Contract #: 04-0120F4Cty: SF/ALA Rte: 80 PM: 13.2/13.9File #: 69.25B**QUALITY ASSURANCE -- NON-CONFORMANCE REPORT****Location:** Changxing Island, Shanghai, P.R. China**Report No:** NCR-000710**Prime Contractor:** American Bridge/Fluor Enterprises, a JV**Date:** 15-Apr-2010**Submitting Contractor:** Zhenhua Port Machinery Company, Ltd (ZPMC), Changxing Island**NCR #:** ZPMC-0677**Type of problem:**

Reference Description: Welding Without Approved WPS, Insufficient QC Coverage**Description of Non-Conformance:**

Job Name: SAS Superstructure
Document No: 05.03.06-000667

Subject: NCR No. ZPMC-0677

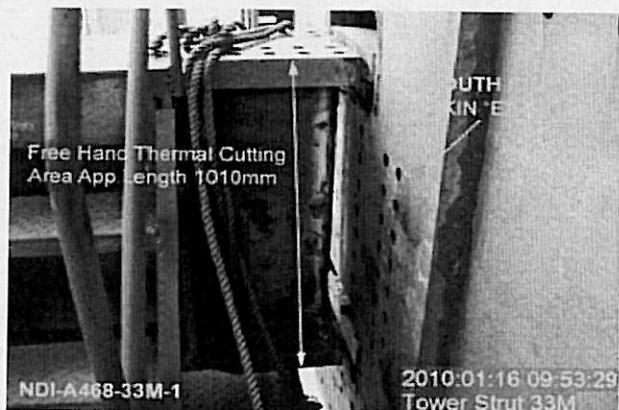
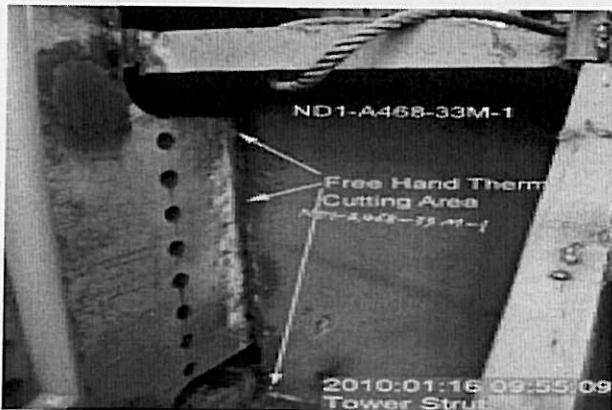
During the random Quality Assurance(QA) in process verification of Tower strut, this QA Inspector observed the following issues:

- Free hand thermal cutting were carried out on edges of the strut plate towards South Tower side without Engineer's approval.
- The strut is identified as ND1-A468-33M-1 at elevation level 33M.
- The thermal cut area is measured approximately 1010 mm.
- The material is designated as Seismic Performance Critical Member (SPCM).
- The member is located at Tower assembly area (Jetty Area).

AWS D1.5 (02) Section 3.2.3: "Steel and weld metal may be thermally cut, provided a smooth and regular surface free from cracks and notches is secured, and provided that an accurate profile is secured by the use of a mechanical guide. Freehand thermal cutting shall be done only where approved by the Engineer."

ZPMC has taken action to repair these areas by buttering, and hole edge distance can also be satisfied. Now this strut has been green tagged.

焊缝返修位置示意图:
Draft of Welding Discontinuity:

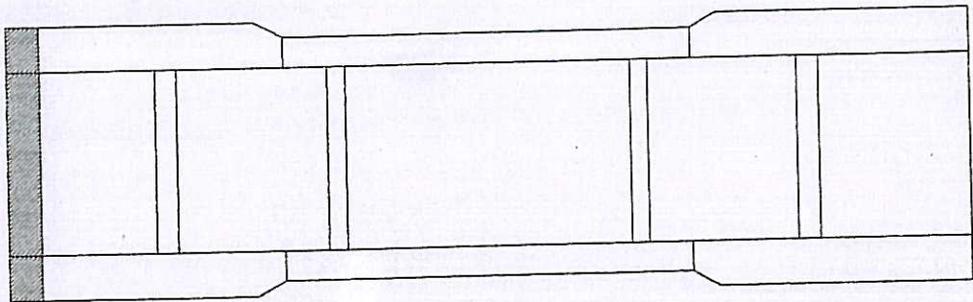
焊缝缺陷描述:
Description of welding discontinuity:
 南塔E面33米联系梁总拼时由于塔柱之间干涉, 对联系梁端部进行修割, 割除部分约5-13毫米, 现在要求堆焊处理, 堆焊长度约5-13毫米。具体如下图所示:
 During splice South tower Skin E 33m strut plate and tower, trim strut plate 5-13mm, and needed to build up 5-13mm, the detail sees the following draft.

注: 阴影部分为堆焊区域
 Remark: repair area in shadow.

1. QC/CWI shall monitor and direct all grinding and welding during the repair procedure.
2. Grind the repair area smooth
3. Verify that no defects are present by VT and MT prior to welding
4. Apply backing bar and weld
5. Preheat and maintain interpass temperature control according to the approved WPS
6. QC shall ensure all slag has been removed prior the deposition of next pass
7. The weld size should be greater than theoretical size by about 2 to 3mm.
8. Remove backing bar and grind the weld area smooth after buttering
9. Perform VT, MT and UT inspection on the repaired area

Reference Description: Welding Without Approved WPS, Insufficient QC Coverage/ Tower / Tower Skirt

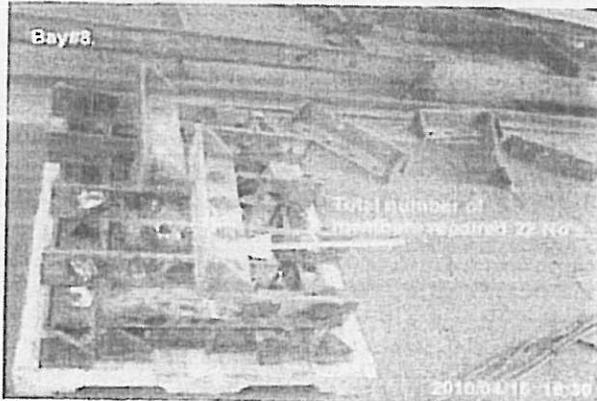
During Quality Assurance (QA) random in-process observations of the fabrication of Tower skirt connection angles Caltrans QA discovered the following:

- ZPMC Personnel performing plug welded restoration of the material with mis-located drilled bolt holes without approved repair Weld Procedure Specification (WPS).
- ZPMC Certified Welding Inspector (CWI)/Quality Control Inspector (QC) were not observed as being present during the welding process from 10:00 to 11:00 hours.
- The welding was being performed by using Flux Cored Arc Welding (FCAW) process.
- The members are identified as Tower skirt connection angles.
- Total number of skirt angles repaired: 22 ea.
- These members are located in Bay #8.

AWSD D1.5:2002, Sec. 1.9: "All production welding shall be performed in conformance with the provision of an approved Welding Procedure Specification (WPS)..."

AWS D1.5 2002, Sec. 3.7.7.1: "Base metal not subjected to dynamic tensile stress may be restored by welding, provided the Contractor prepares and follows a repair WPS. The repair weld soundness shall be verified by UT or RT as approved by the Engineer."

Propose a resolution for the identified non-conformance, documenting that the plug welded restorations are in compliance with the contract requirements. Documentation provided for the Engineer's review of the acceptability of the weld repairs shall at a minimum include the procedure utilized and the NDT results.

NCR #: ZPMC-0677

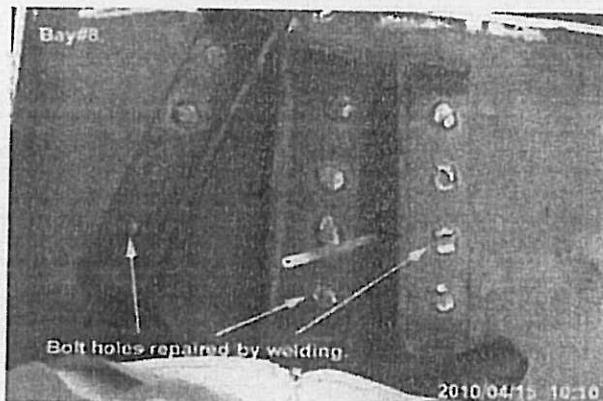
During Quality Assurance (QA) random in-process observations of the fabrication of Tower skirt connection angles Caltrans QA discovered the following:

- ZPMC Personnel performing plug welded restoration of the material with mis-located drilled bolt holes without approved repair Weld Procedure Specification (WPS).
- ZPMC Certified Welding Inspector (CWI)/Quality Control Inspector (QC) were not observed as being present during the welding process from 10:00 to 11:00 hours.
- The welding was being performed by using Flux Cored Arc Welding (FCAW) process.
- The members are identified as Tower skirt connection angles.
- Total number of skirt angles repaired: 22 No's.
- These members are located in Bay #8.

Contractor will fabricate new pieces of connection angles to replace the mis-drilled connection angles. Contractor will issue an internal NCR to the QC. Contractors will address issue with their staff to improve the performance.

Contractor fabricated new pieces of connection angle to replace the mis-drilled components. Internal NCR issued to the QC and the issue has been addressed with the staff concerned.
